SUBJECT: JUNE 2-4, 2003, MEETING SUMMARY: MEETING WITH DUKE
COGEMA STONE & WEBSTER TO DISCUSS CHEMICAL SAFETY
RELATED TO MIXED OXIDE FUEL FABRICATION FACILITY

**MEETING SUMMARY
MOX FUEL FABRICATION FACILITY
June 2-4, 2003**

The purpose of the meeting was to discuss the draft Safety Evaluation Report (SER) chemical safety open items related to the construction authorization request (CAR) for the MOX Fuel Fabrication Facility (MFFF).

**Resulting Airborne Concentration as a Function of Wind Speed Over the Spill
(500 liters of 13.6 N Nitric Acid Spilled over 50 sq. m)**

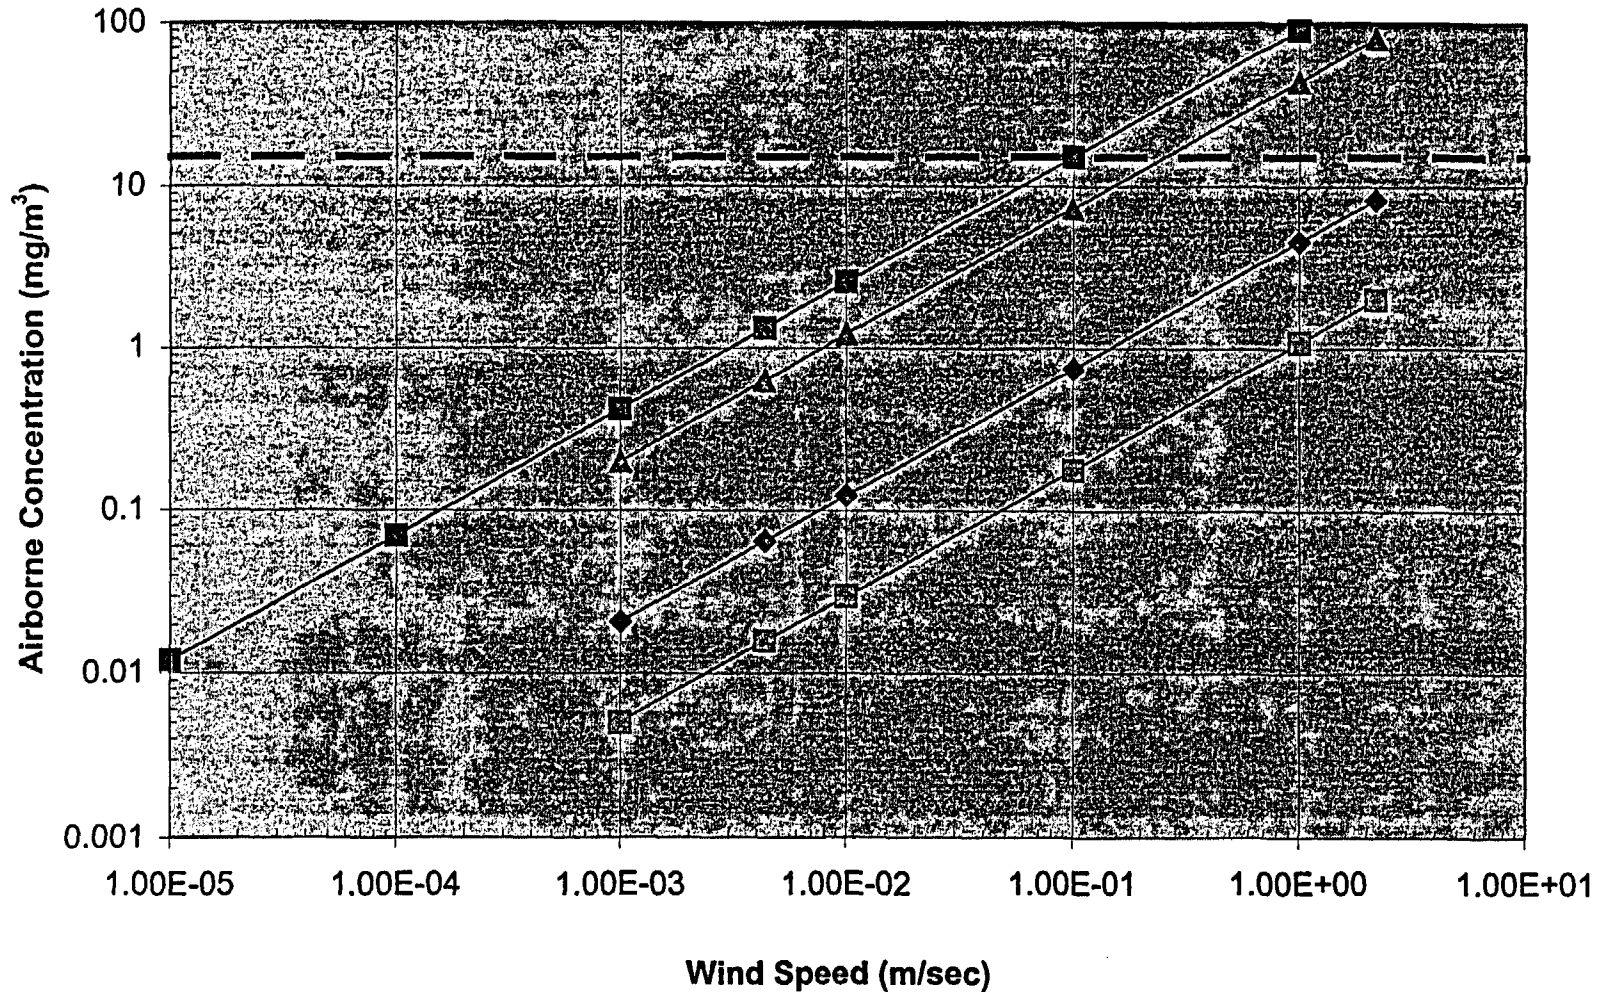
This item involved the effect of indoor airspeed on the calculational model used for determining whether a hot nitric acid spill in a cell could result in exceeding the performance criteria in 10 CFR Part 70. The applicant determined that for an uncontained spill and an average indoor airspeed of 0.01 m/sec, no consequence limits would be exceeded. The staff was concerned that the 0.01 m/sec airspeed was not realistic due to possible air duct locations near floor level that could significantly affect the evaporation rate of an uncontained spill. Specifically, the evaporation model is very sensitive to airspeed above the spill and an increase to 1 m/sec could exceed the low consequence limits. Additionally, the evaporation rates increase with temperature and could be substantial for temperatures above 110°C.

The staff conducted independent calculations using three different techniques (the guidance in NUREG/CR-6410, Nuclear Fuel Cycle Facility Accident Analysis Handbook, ALOHA and EPICode) and determined that the indoor air speed would conservatively have to be greater than a factor of five times the assumed average wind speed of 0.01 m/sec. to exceed the ERPG-2 value for a hot nitric acid spill (119°C) in the C-105 cell floor to exceed the low consequence limits for the site worker. The calculations assumed that the spill covered the entire 60m² floor area and did not take into account the conservative effects of the spill catch pan under the tank that is designed to contain the entire tank volume, or cooling from contact with the floor surface.

In addition to the above, DCS will do a cell by cell review during the ISA to confirm that low consequence limits will not be exceeded for any uncontained spill. Should the limit be exceeded, DCS indicated that the existing spill catch pan, already a principal structure systems and component (PSSC) for other scenarios, would be upgraded to a PSSC for this scenario. Since (1) there is a substantial indoor airspeed margin, (2) a cell by cell review will be conducted during the ISA, and (3) should the low consequence limits be exceeded for any cell assuming an uncontained spill (i.e., no catch pan), the applicant will upgrade the existing devices to PSSCs without impact on any construction activities, the staff considers this item closed.
